## ADAMS NORTH TECHNOLOGY CENTRE JSP19-05

Consideration at the request of Northern Equities Group for Preliminary Site Plan and Storm Water Management plan approval. The subject property contains 6.7 acres and is located in Section 1, on the north side of MacKenzie Drive east of the planned extension of Cabot Drive, part of the Haggerty Corridor Corporate Park. The vacant parcel is zoned OST, Office Service Technology. The applicant is proposing to construct a one-story building with office space and laboratory space totaling 56,429 square feet. This project was approved in 2014 and returned to Planning Commission for approval in 2017, but was never built.

Approve/Deny the Preliminary Site Plan and Storm Water Management Plan.

# PLAN REVIEW CENTER REPORT

**DIMENSION & PAVING PLAN - WEST**  
**ADAMS NORTH TECHNOLOGY CENTRE**  
 SECTION 1 - CITY OF NOVI, OAKLAND COUNTY, MICHIGAN 48377

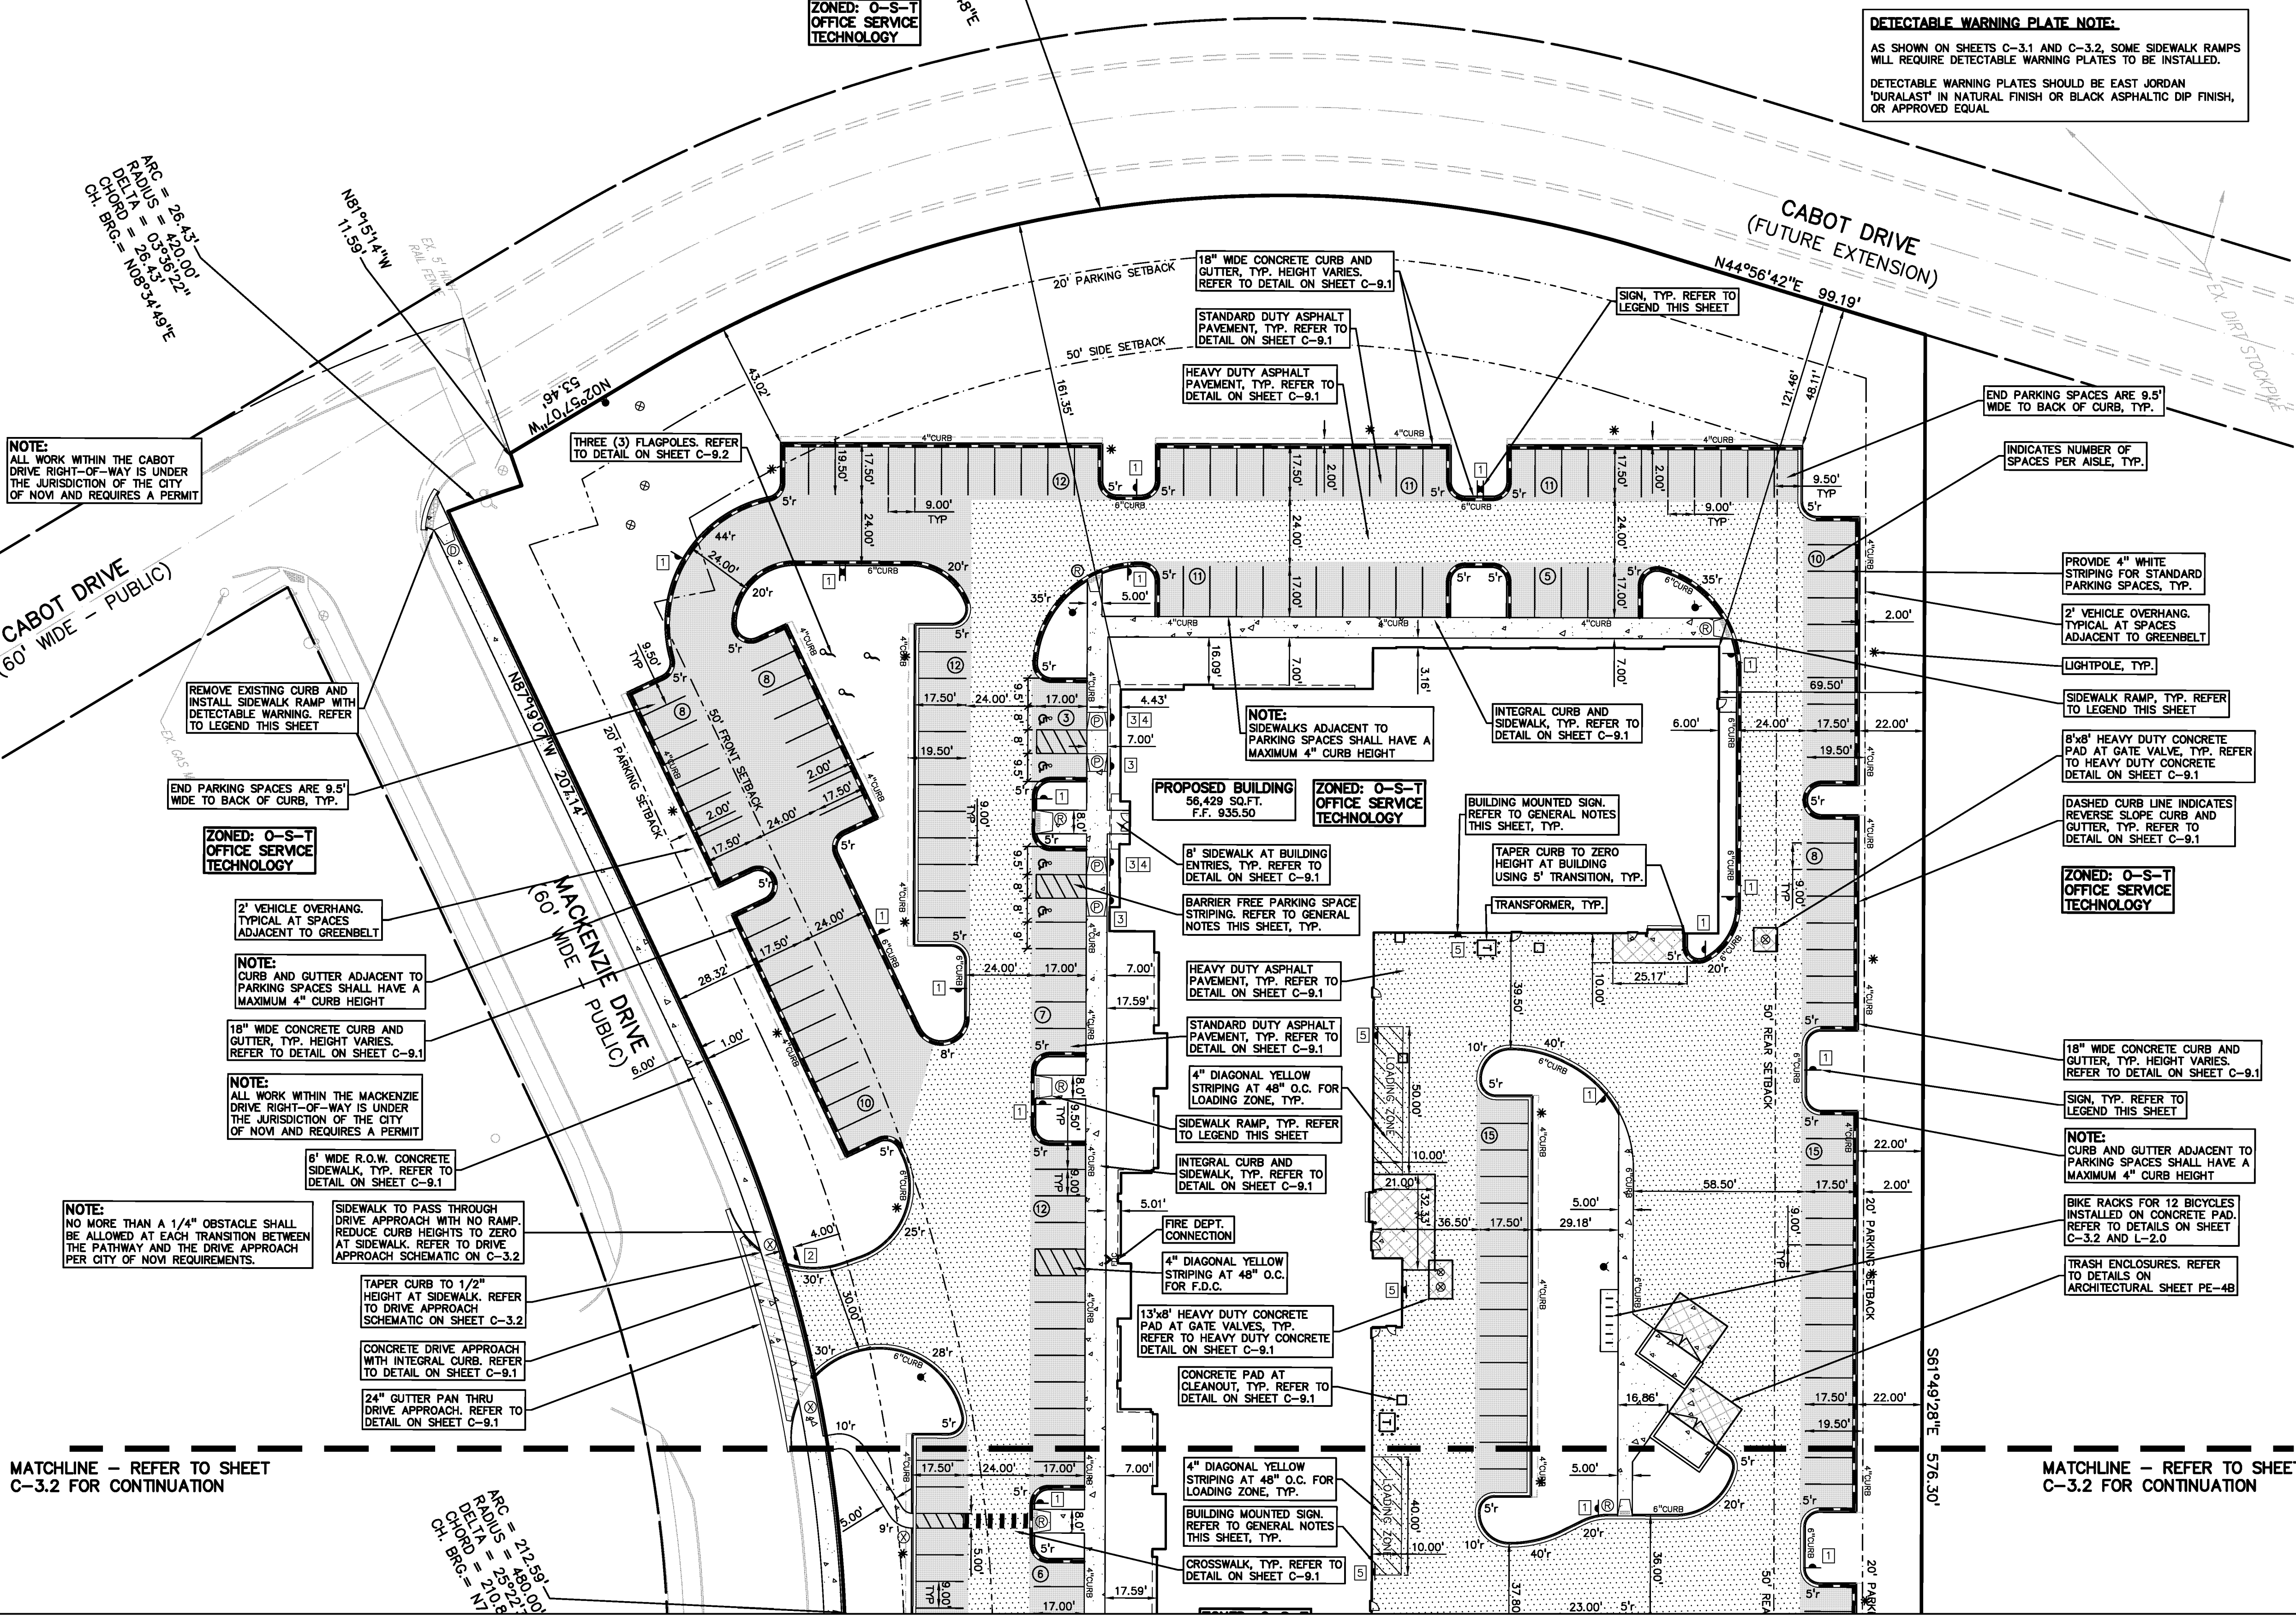
- b. A waiver from Section 5.3.12 for end islands with smaller than minimum required 15' outside radius (8' proposed) given that a turning movement diagram will be provided by the applicant at the time of revised Final Site Plan to show that it is maneuverable, which is hereby granted;

4. End Islands (Sec. 5.3.12): End islands should have a minimum 15 foot outside radius. The plan indicates only an 8' radius and 10' radius for some end islands. **The applicant should provide a turning movement plan to show maneuverability around the end islands and indicate a request for the waiver, or adjust the plans to meet requirements.**

DRAWING NUMBER:  
**L-1.0**

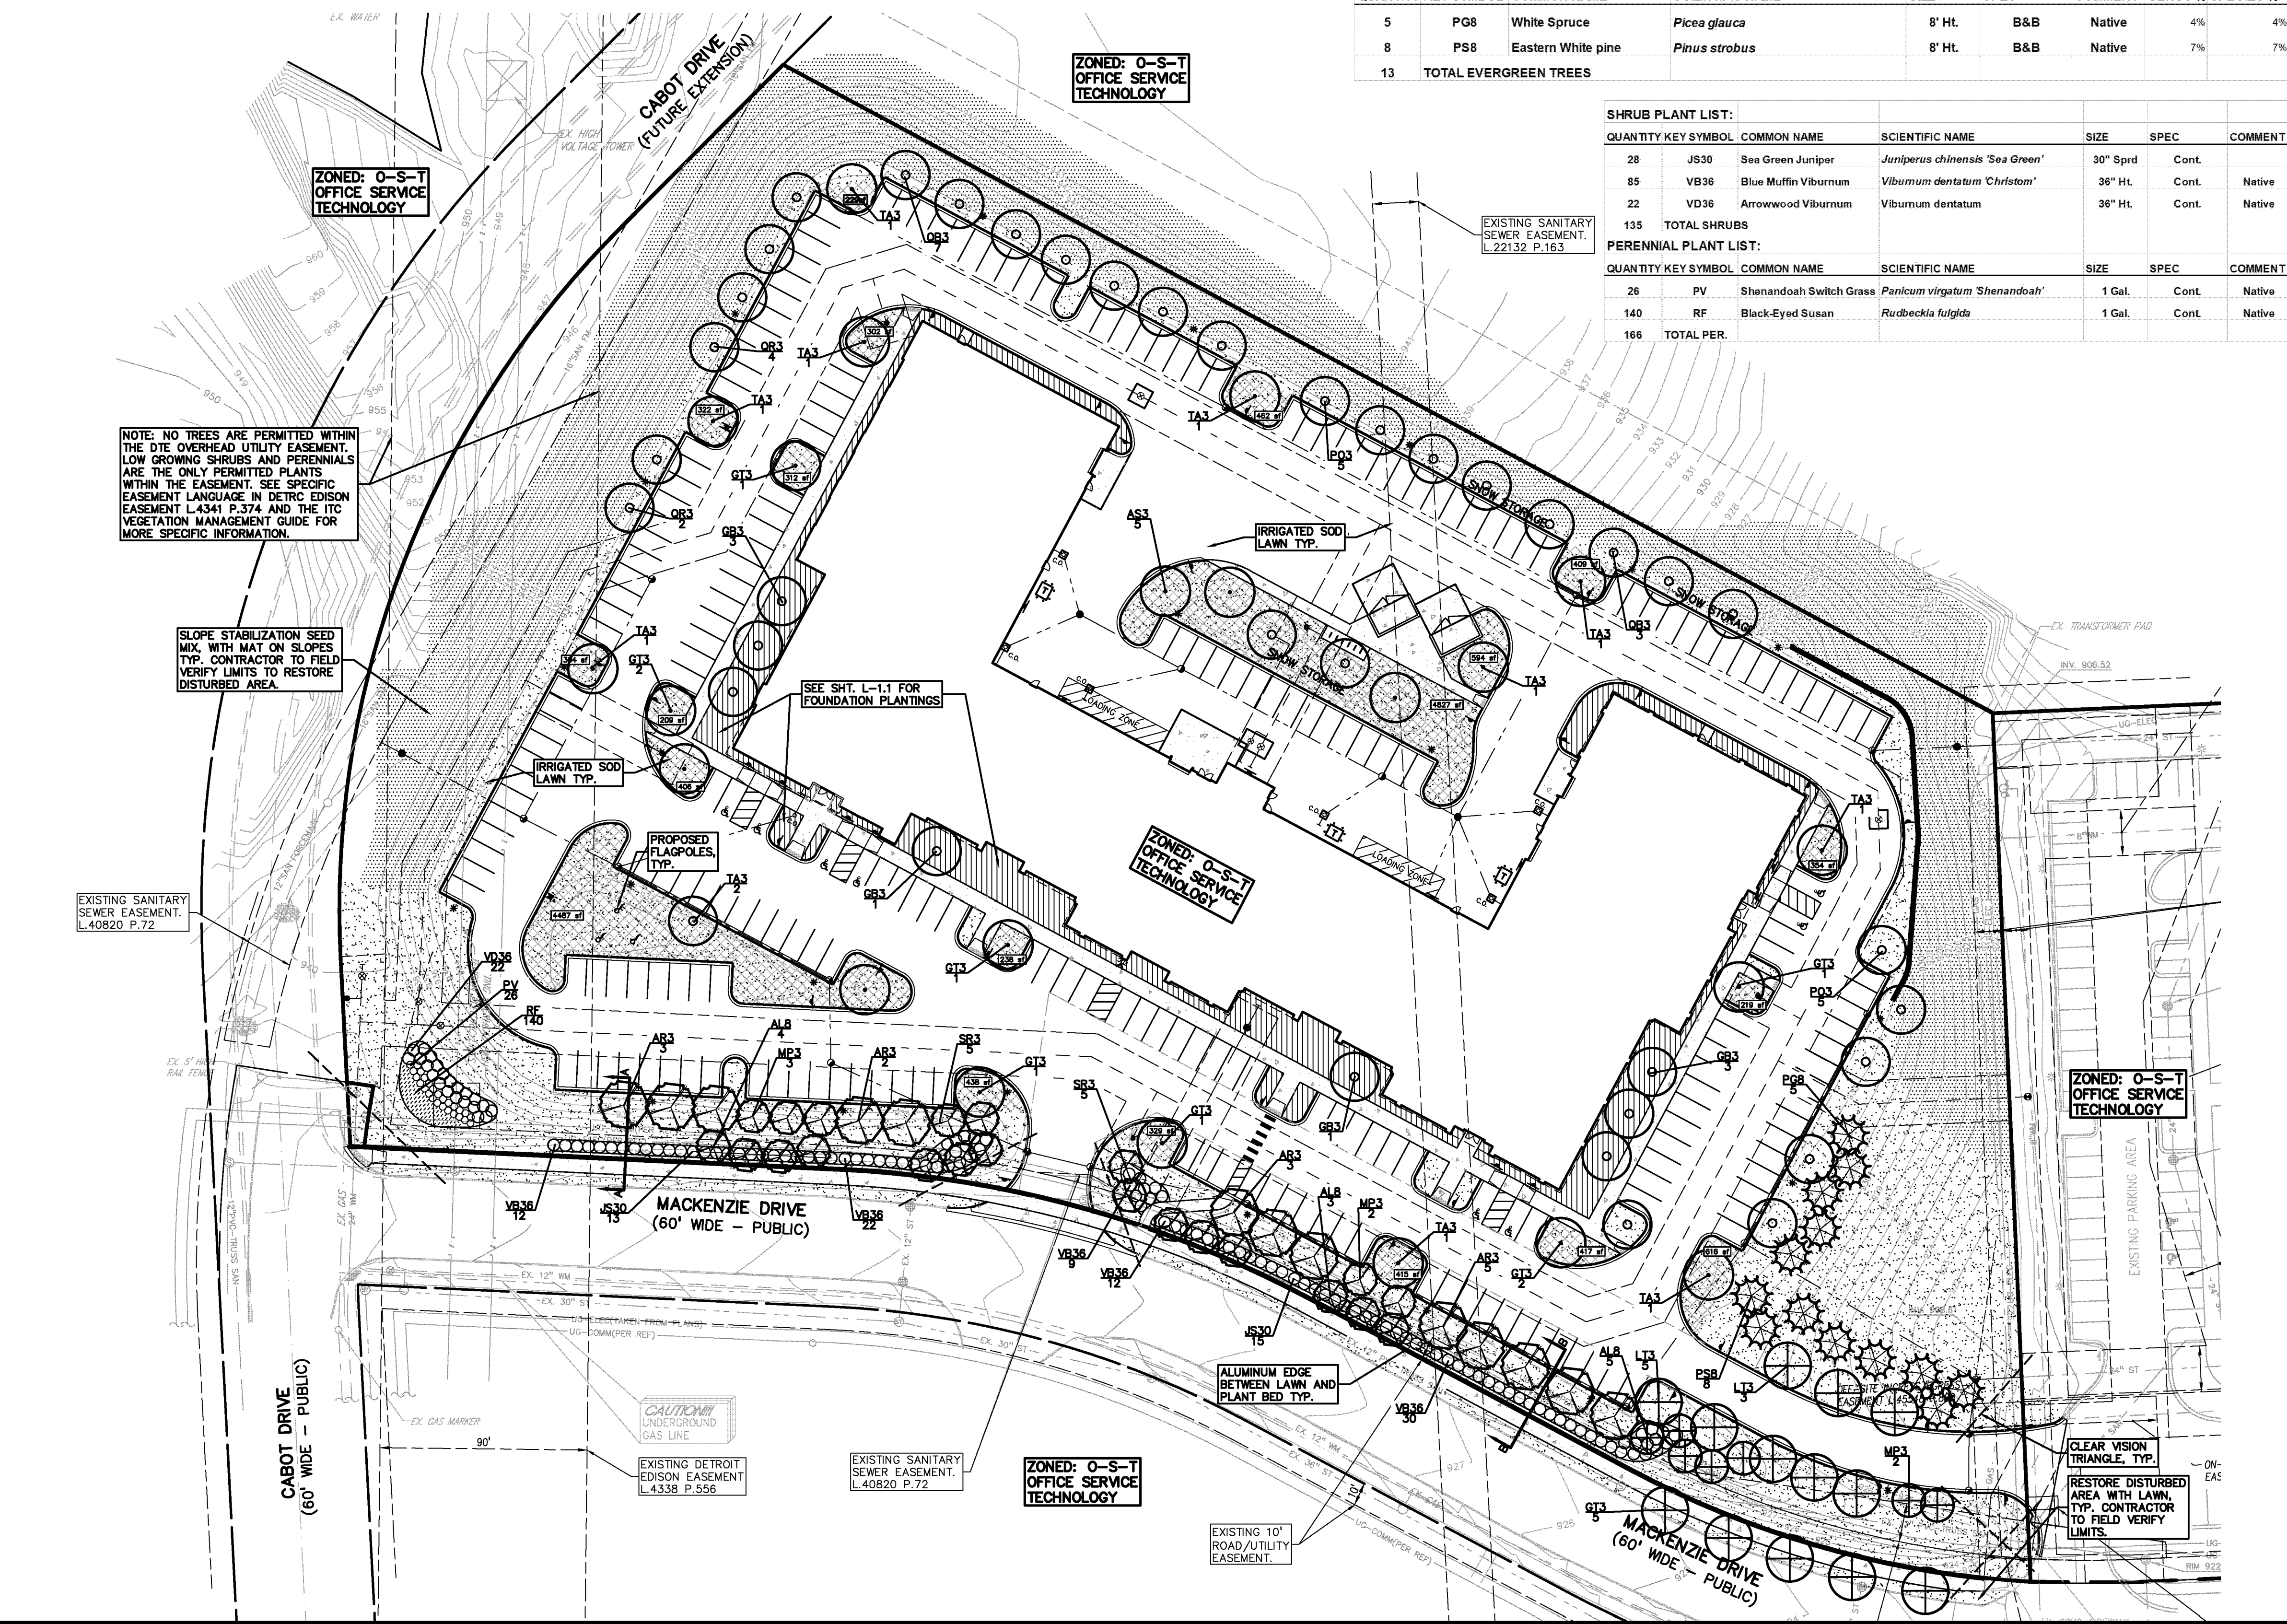
- a. Landscape Review: **Four waivers are required for lack of parking lot interior trees and perimeter trees within the ITC Corridor, lack of building coverage by foundation landscape, and lack of screening around transformers.** Given that the waivers must be granted by the Planning Commission, the revisions can be addressed on a revised Final Site Plan. Landscape recommends approval of Preliminary Site Plan, but not Final Site Plan. Additional comments to be addressed with revised Final Site Plan submittal.

**WEST ELEVATION**  
SCALE: 1/16" = 1'-0"  
**3**

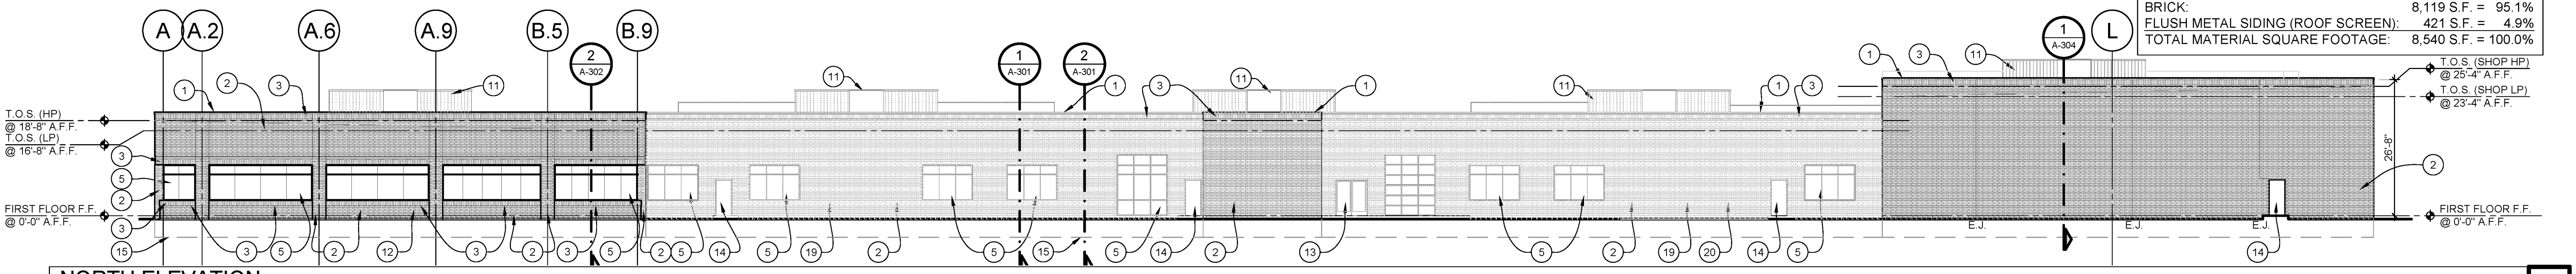
- g. A Section 9 waiver for the underage of brick on the west façade, which is hereby granted;
- h. The findings of compliance with Ordinance standards in the staff and consultant review letters and the conditions and the items listed in those letters being addressed on the revised Final Site Plan; and
